Standard Terminal Automation Replacement System Human Factors Review

Prepared by:
Standard Terminal Automation Replacement System
Human Factors Team

Submitted to:
Chief Scientific and Technical Advisor for Human Factors

Early Display Capability
Initial Diagnostic Usability Assessment

Figure 3. Early Display Capability target.

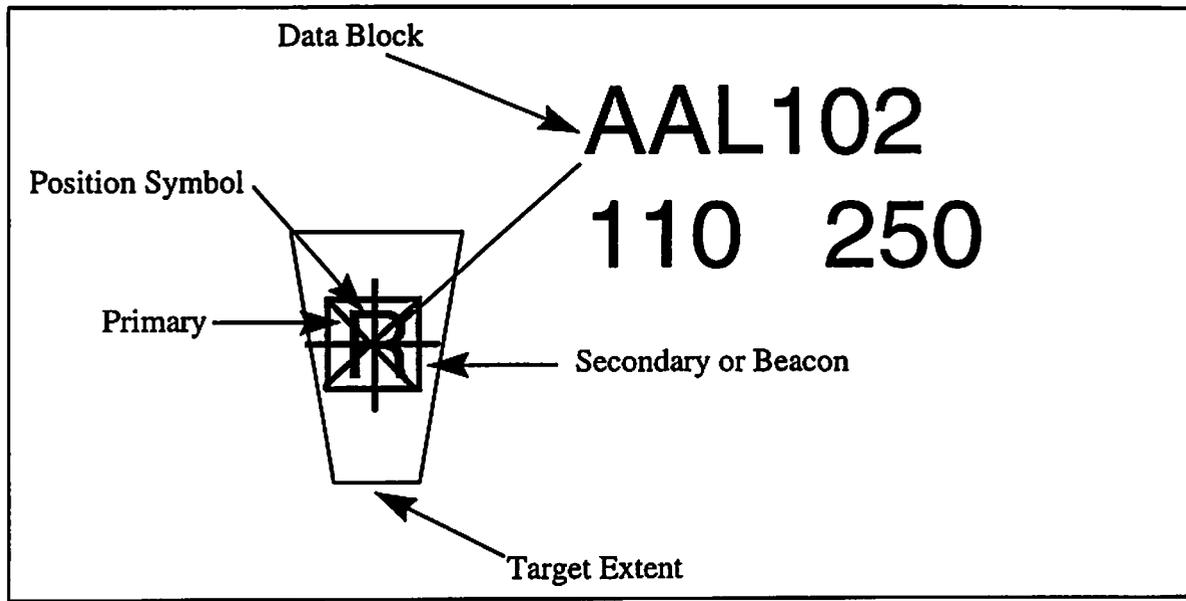
During the assessment, controllers reported that they could not clearly distinguish the EDC target extent, beacon code, and position symbols. STARS Team staff provided advice on display setup to try to rectify this problem on the fourth day of the evaluation. (See Volume II, Section 2 for the information the STARS Team provided.) However, difficulty seeing the position symbol persisted. This included the following issues:

- The method chosen to represent the target extent symbol may make it appear that it is turning as the aircraft moves across the display.
- Some ambiguity and potential impact on controller performance may exist with respect to the standards applied to separation, including those related to the trapezoid size, edge, corner, change in shape, or rotation of the target extent symbol. Controllers noted that excessive separation could be required for simultaneous parallel approaches on parallel runways to avoid the symbol entering the Non-Transgression Zone.

- There were also comments that the history trail color, size, shape, and intensity add to display clutter. The existing ARTS history trails may give more salient information on aircraft rate of turn.
